## **WADE BUSINESS PARK SUBDIVISION**

APPLICATION NUMBER 6 DATE June 15, 2006  
APPLICANT Wade Business Park Subdivision  
REQUEST Subdivision

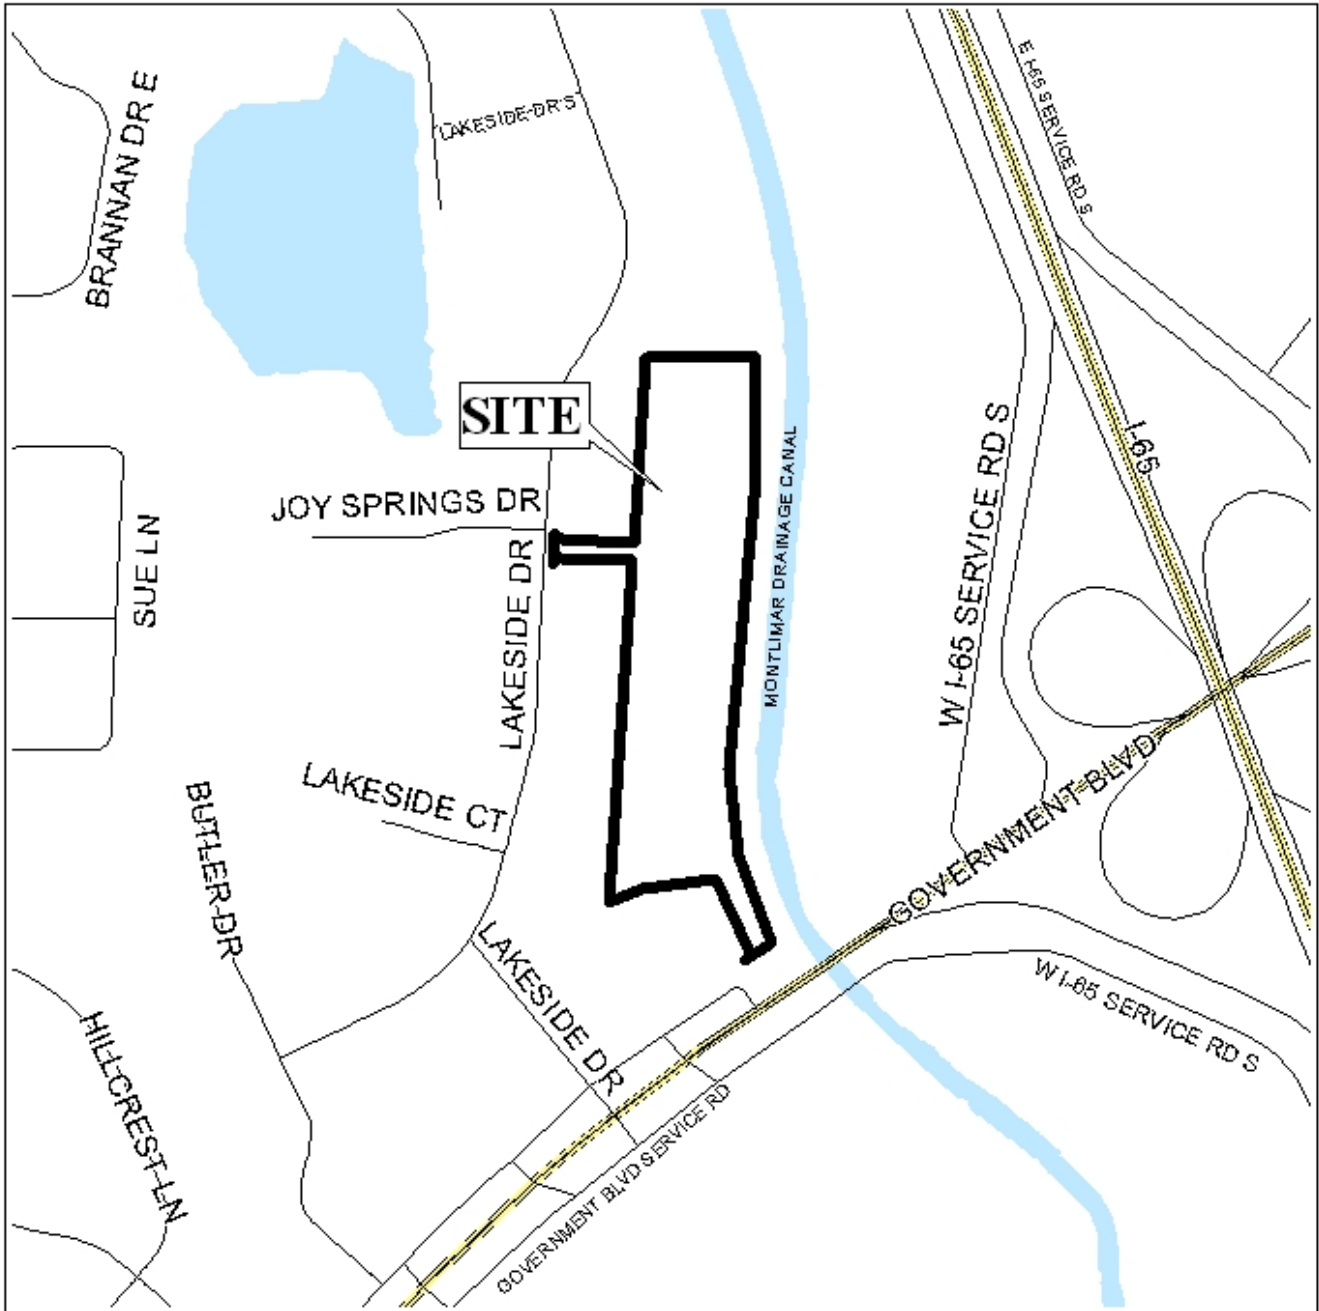
The site previously received approval as a 10-lot subdivision with an access road running along Montlimar Creek; however, the plat was recorded with only one lot, no street, and a "future development" area, which is here presented for subdivision. Furthermore, what is shown in the present application as two proposed "flagpole" accesses to Government Boulevard, is shown on the record plat as a "proposed street". In addition, the flagpole access to Lakeside Drive is shown on the record plat as a public right-of-way. While these access points appear to be approximately 70 feet and 100 feet wide, respectively, these measurements include the curb radii; the true width of each of these is 50 feet.

Given that the earlier subdivision approval was dependent upon the construction of streets to the site, it seems inappropriate to approve this request for flag lots.

It should also be noted that the legal description omits the length for the bearing S 02-36-00 W, which should be provided on the final plat.

Based on the preceding, this application is recommended for Holdover to the July 20<sup>th</sup> meeting, to allow the applicant to submit revised drawings showing no flag lots. Revised materials, including additional lot fees, if necessary, should be received by June 26<sup>th</sup>.
